# Response to Submissions and Amendment Report

*164-172 and 174-194 William  
Street, Woolloomooloo (SSD-  
80211463)*

Director	Sophy Purton
Consultant	Jasmine Foster & Ella Grimson
Project Code	P0036191
Report Number	Response to Submissions and Amendment Report Final – 22 May 2026

Figure 25 Relocated DDA Lift

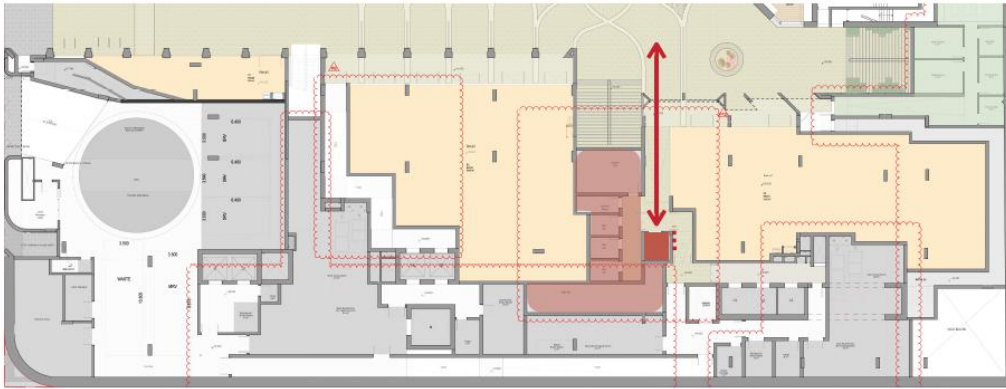
In addition to the above, an opportunity for greater sight lines and passive surveillance to the retail lift core, has been identified and addressed as part of the post-lodgement DIP (DIP 3). Previously, the DDA lift on the ground floor was located behind retail tenancy 03 and not immediately visible from the central park, and access to the retail WC facilities was located behind retail tenancy 02 and accessible through a "dog-leg" walkway. The panel raised this as a potential safety risk for accessing the DDA given that the site is accessible 24/7.

The DDA lift has since been relocated to allow for direct access and a clear visual connection from the publicly accessible Central Plaza and the public domain on William Street (see **Figure 16** below). It is understood that this refinement better aligns with the CPTED principles in promoting passive surveillance across the development.

Revised Forbes Street (Plaza) level showing modifications to the access to the DDA lift requested
